NOTE FOR: Phil Justus

FROM: Keith McConnell

SUBJECT: ADDITIONAL EVIDENCE FOR POSSIBLE FAULTING IN THE VICINITY OF THE EXPLORATORY SHAFTS

Attachment 1 (After Scott & Bonk 1984)
USW G-1
USW H-1
HOLE
WASH
WREN
WASH
YUCCA
RIDGE
COYOTE
WASH
USW G-4
YUCCA
RIDGE
SPLIT
WASH
RIDGE
BACK
RIDGE
UE25a-4
UE25a-5
UE25a-6
UE25a-7
UE25b-1H
UE25a-1
ESE
4300
4200
4100
4000
3800
4318
4028
QTac

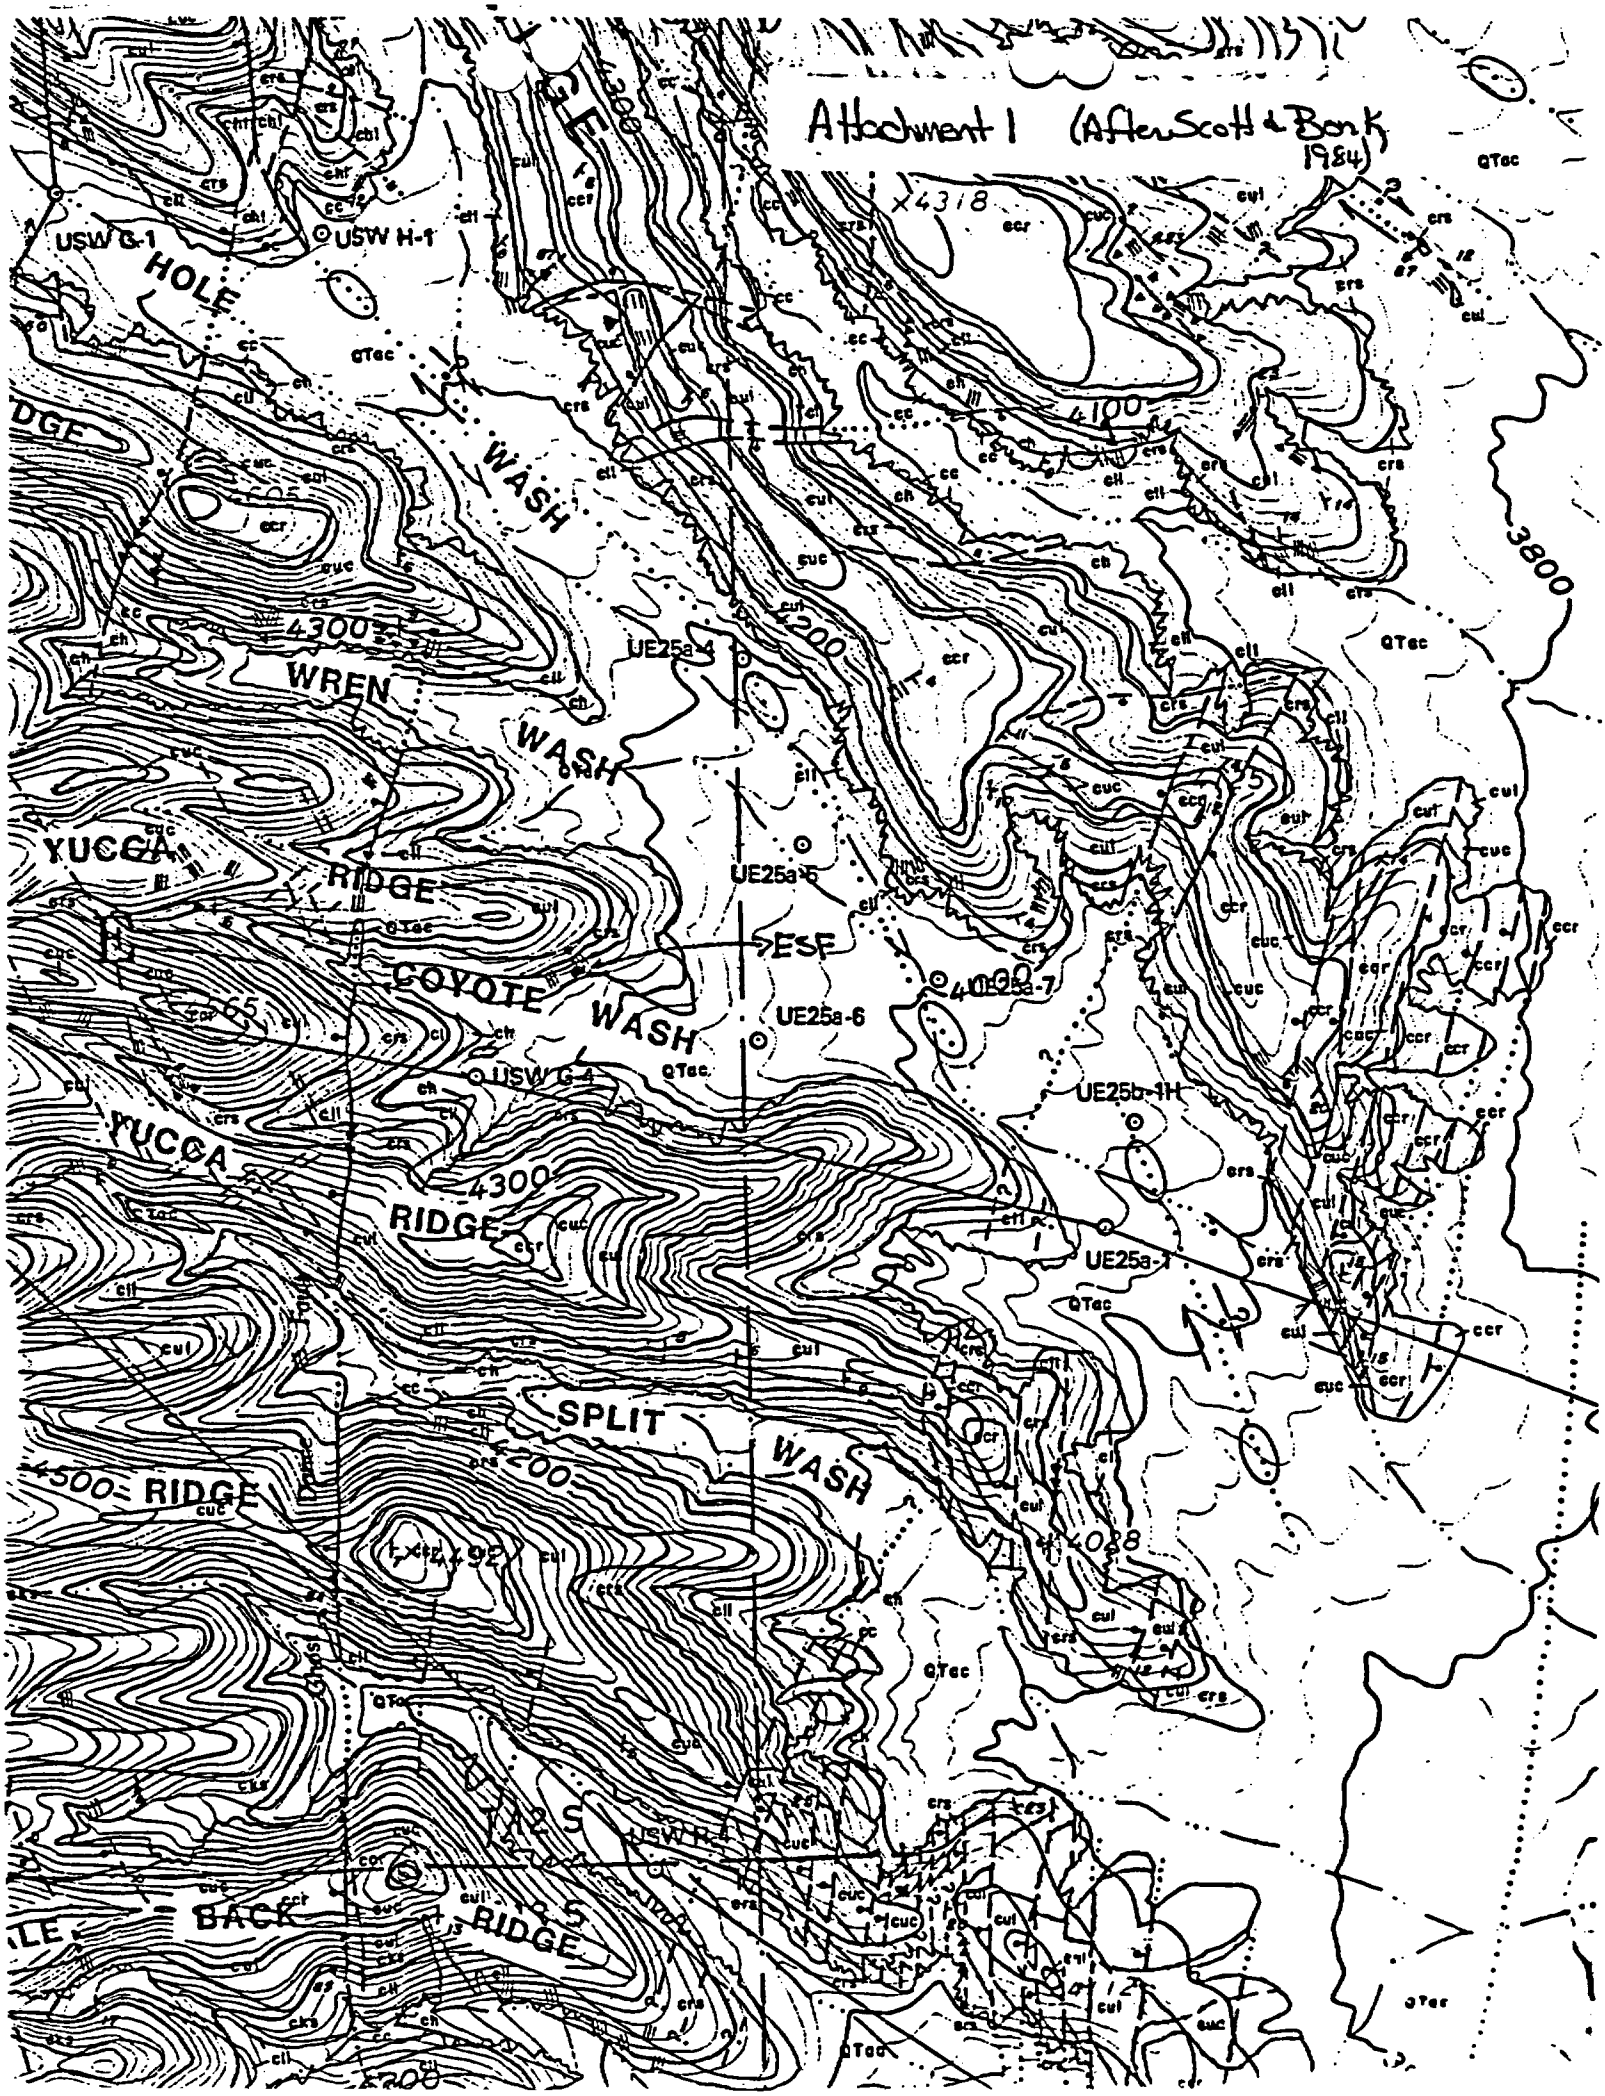
Attachment 1 shows the relationship between borehole G-4, the exploratory shaft locations, and borehole UE25a-6. The boreholes are approximately 1400 ft. apart and borehole UE25a-6 is approximately 1000 ft east of the exploratory shaft locations. Both boreholes appear to be within the CPDB. A comparison of some pertinent data derived from the two boreholes is listed below.

Assuming a uniform dip of 9 degrees (i.e., average of dips in boreholes) to the northeast, the base of the Tiva Canyon at UE25a-6 should be approximately 221 feet below the level indicated in G-4 (i.e., 3806.9'). However, the base of

the Tiva Canyon is at an elevation of 3907' in UE25a-6 (Spengler and Rosenbaum, 1980), a difference of 100'.

1) Why is the thickness of the alluvium in UE25a-6 (which is east of and presumably in a deeper part of Coyote Wash than G-4) equal to or less than that in G-4?

2) Why is the orientation of bedding so distinctly different between boreholes G-4 and UE25a-6?

3) Why is the elevation of the base of the Tiva Canyon 100' higher than would be suggested by a uniform dip of 9 degrees to the east?

4) What is the significance of the statement by Daniels and others (1981) that near-surface fracture zones may be present near UE25a-6 when viewed in the context of the poor core recovery and the areas of intense fracturing near the location of the exploratory shafts?

Perhaps the most significant question regarding the data available from UE25a-6 is why a simple cross-section between boreholes G-4 and UE25a-6 has not been presented by DOE. These two boreholes are the closest boreholes to the ES locations. No documentation has been presented to suggest that data related UE25a-6 was considered in the present location of the shafts or to indicate that this information is under consideration in the Technical Assessment Review.
